CANDLEWOOD SUITE HOTEL | CHERRY HILL SWEDISH CAMPUS

PLAN CHANGES FROM 09-11-2019 SAC MEETING - HOTEL PROPOSAL

505 16TH AVE, SEATTLE

EXISTING (NORTH & WEST)

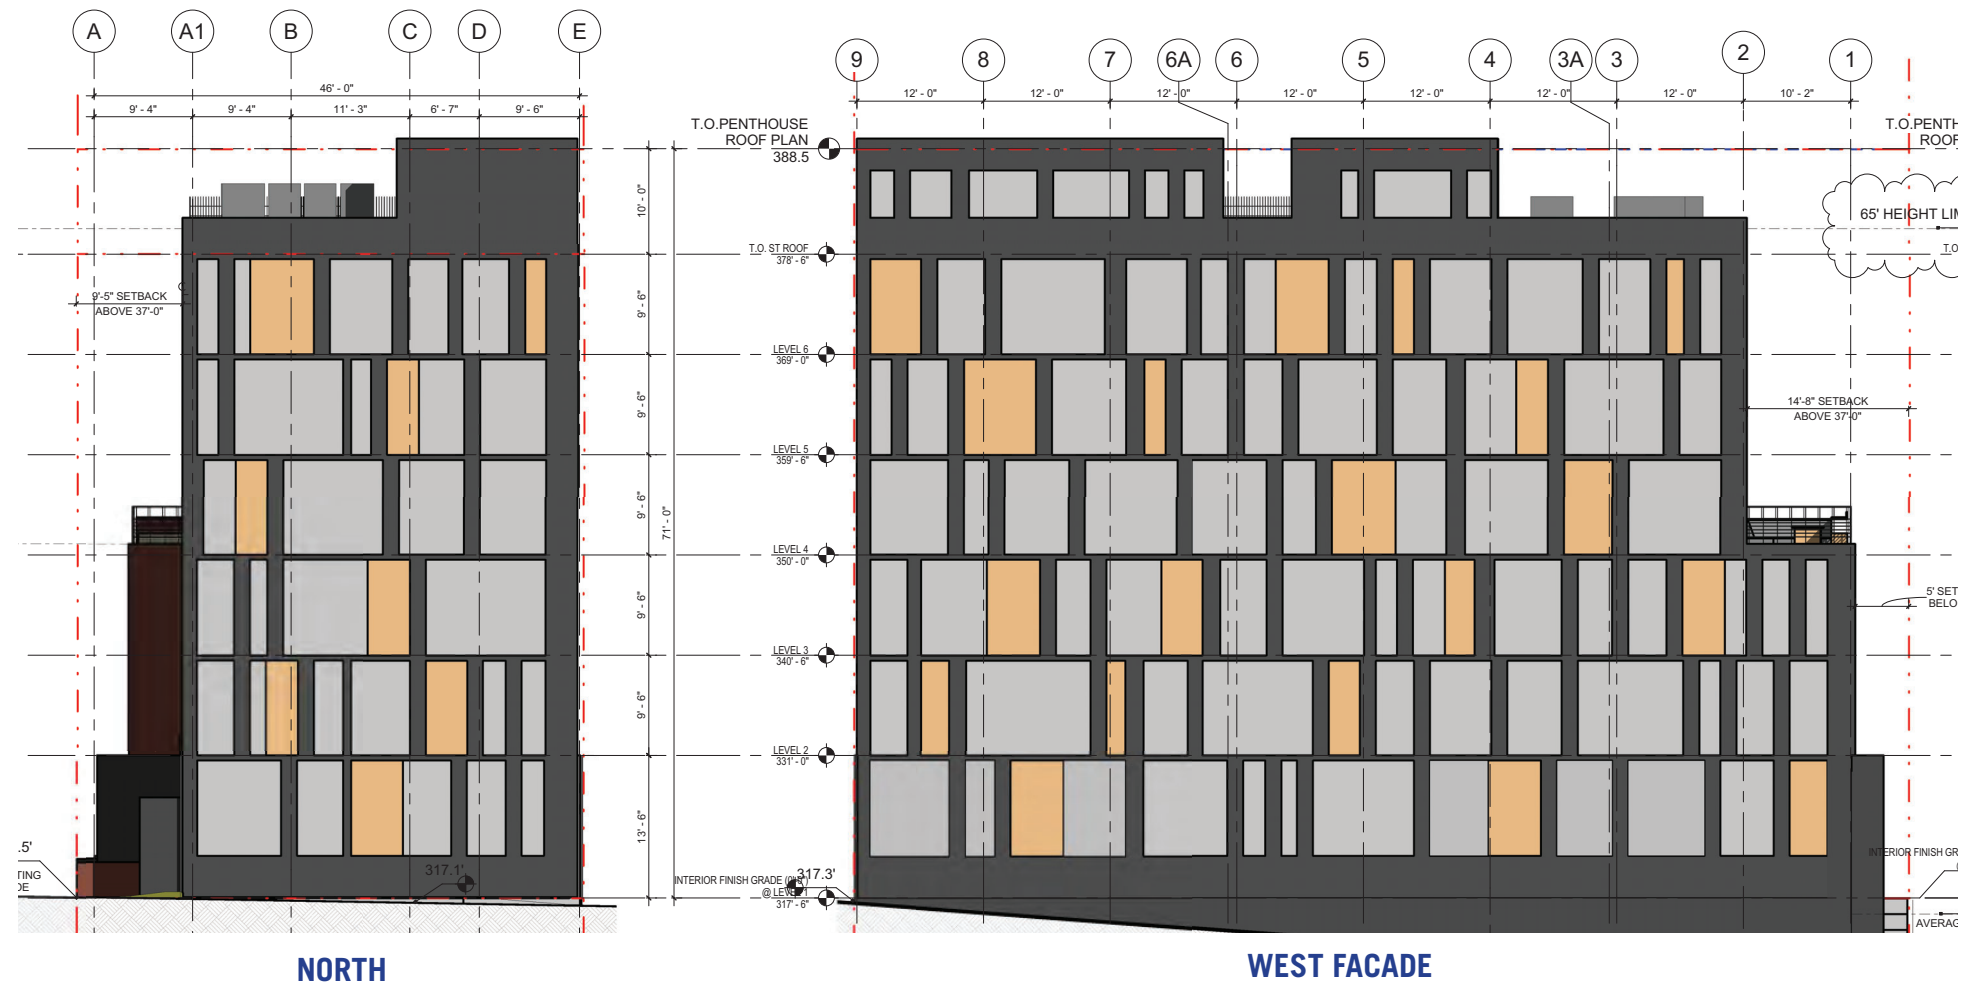
- EXISTING FACADE IS PROPOSED AS SMOOTH FIBER CEMENT PANELS IN PAINTED BLOCK ARRANGEMENTS
- NO WALL MODULATION AT N & W WALLS
